TO: PLANNING BOARD
FROM: JAMIE STEFFEN, TOWN PLANNER
SUBJECT: ITEM 2 – 459 US ROUTE 1 – HOTEL BUILDING DESIGN PLANS
DATE: DECEMBER 5, 2019

Memorandum

Project: TownePlace Suites by Marriott
Kittery, Maine
BMA Project Reference J-3135

3-Story Sloped Roof Option

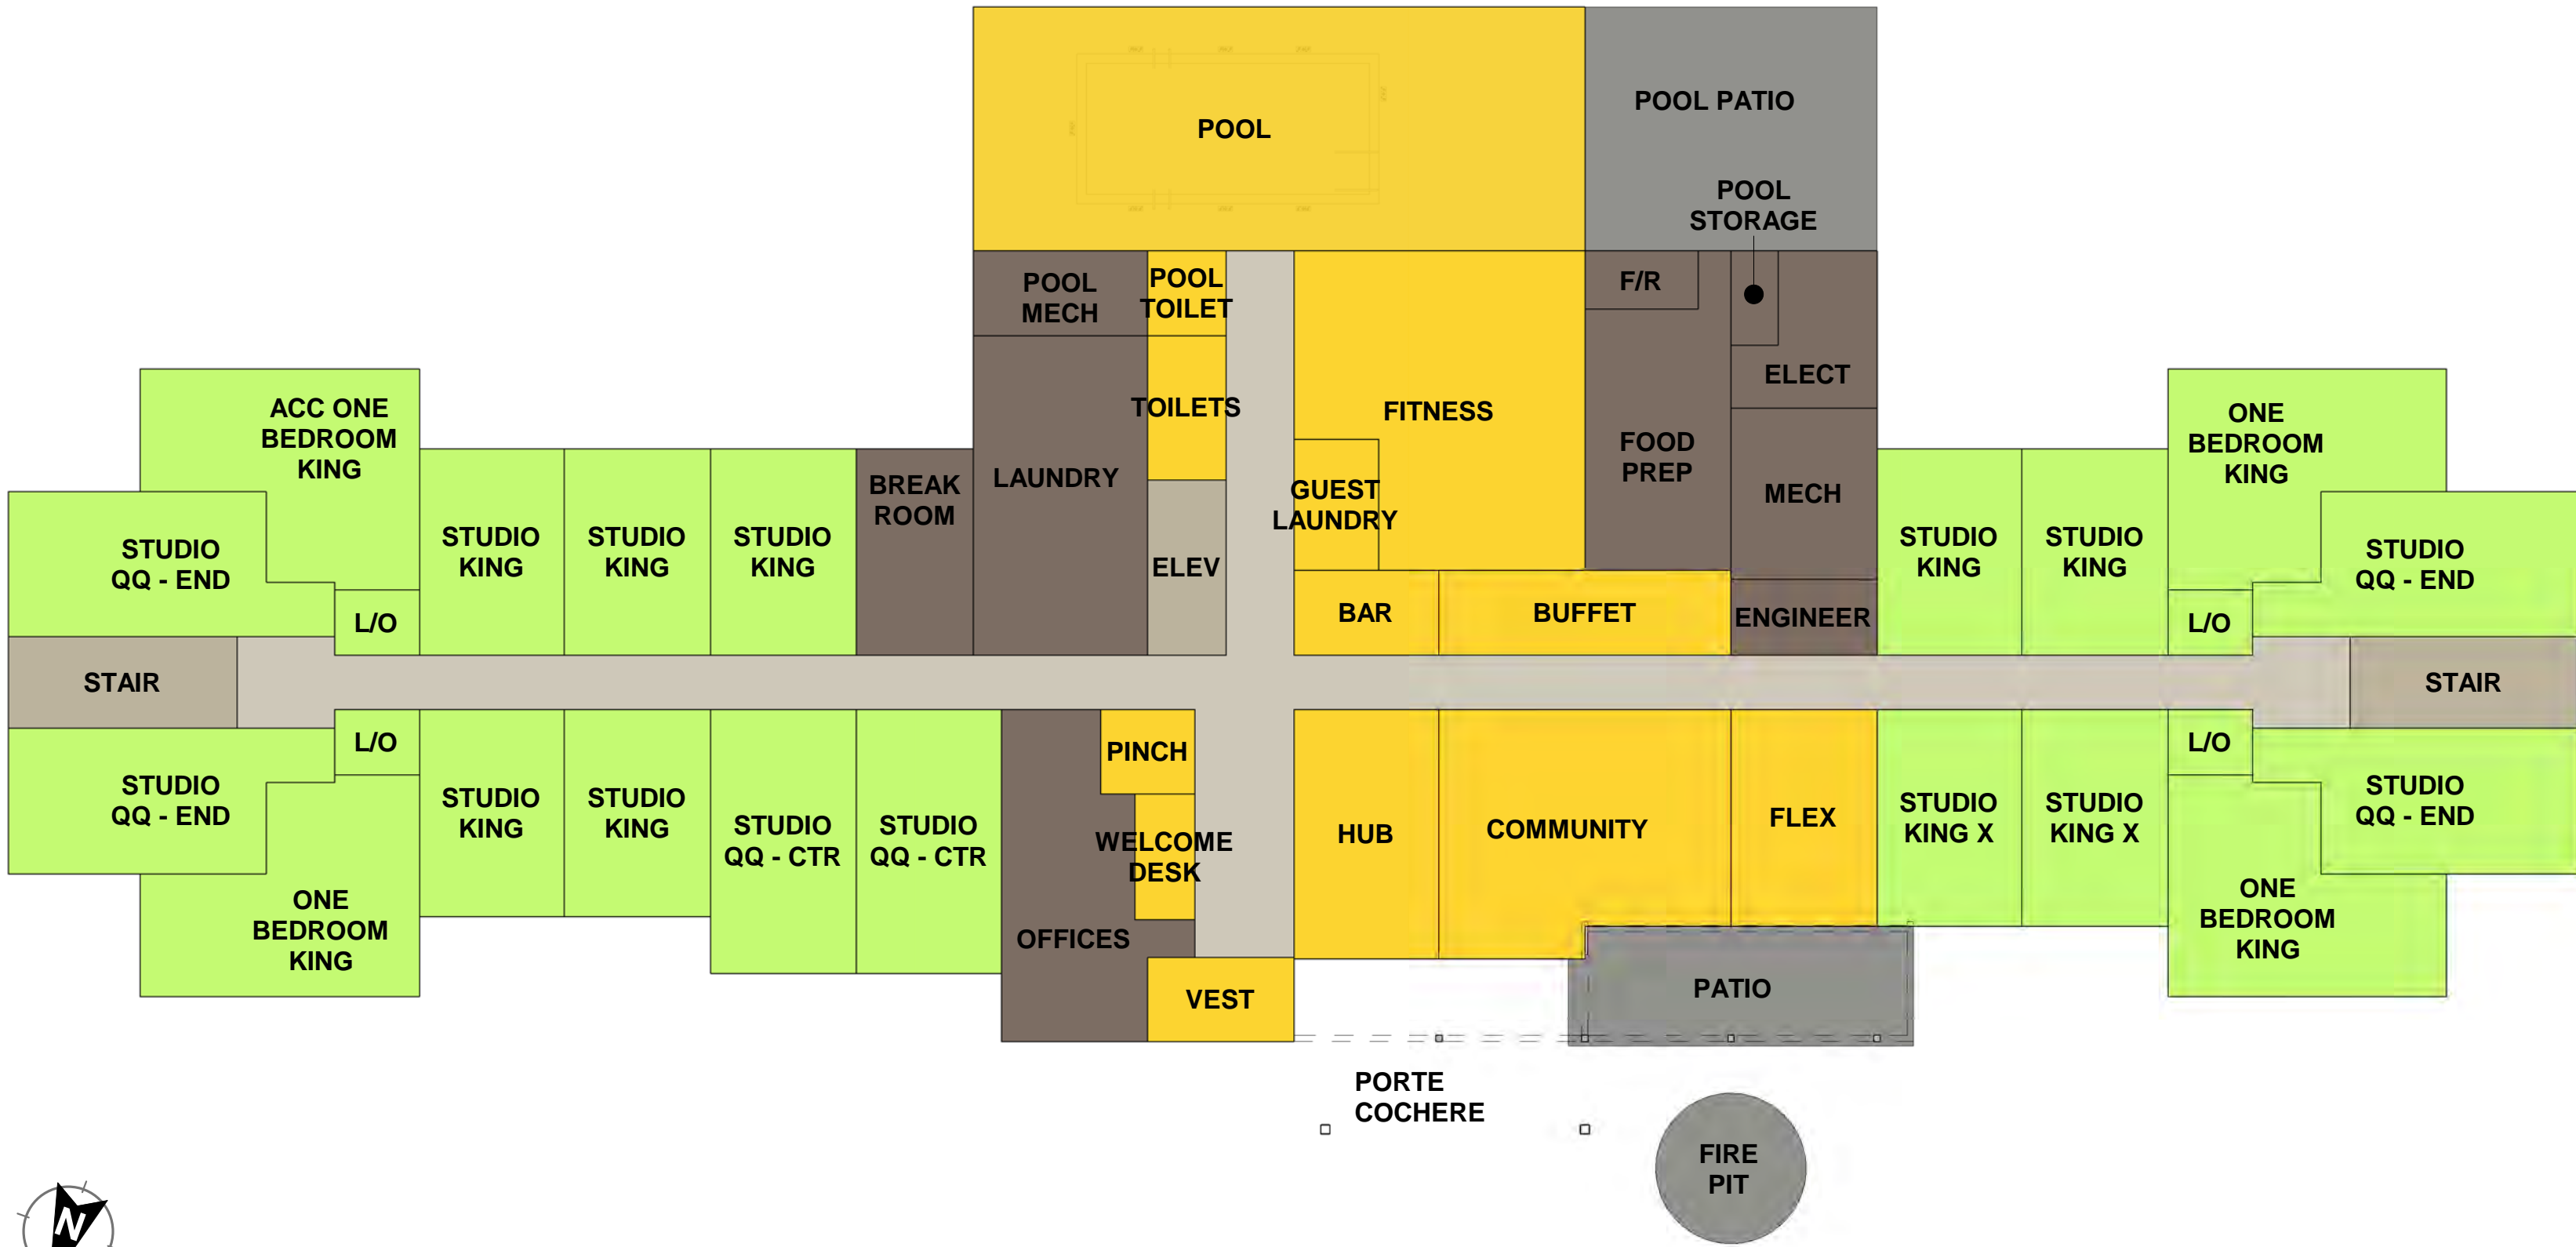
Lastly, there is a concern about massing if the building incorporates a sloped roof. We investigated designs for both a 4-story flat roof and 3 story sloped roof configurations. As depicted below you can see that based on the code definitions the 4-story flat roof option is marginally taller than the 3 story sloped roof design (40'-0" to top of 4 story flat roof versus 37'-7" to the midpoint of the 3 story sloped roof). The overall height of the 3-Story sloped roof is 43'-6" which will increase the perceived scale of the building. The largest challenge with the 3-story sloped roof option is the increase in building length required. The 3-story building is 78'-0" longer than the 4-story option to maintain the market driven 112+ rooms. This would have impact on the site. While the building would still physically fit in the proposed area it would greatly reduce the landscape/green area around the building, increase impervious surfaces, increase perceived scale and decrease views in and around the development.

In the end, we determined that the best course of action is to utilize a flat roof 4-story structure with a Building Height of 40'-0", which complies with maximum building height requirements set by the town. This reduces the footprint by 4,150 square feet, as compared to a 3-story building. This configuration will help to reduce impervious area on the site, while also opens up the space for landscaping.
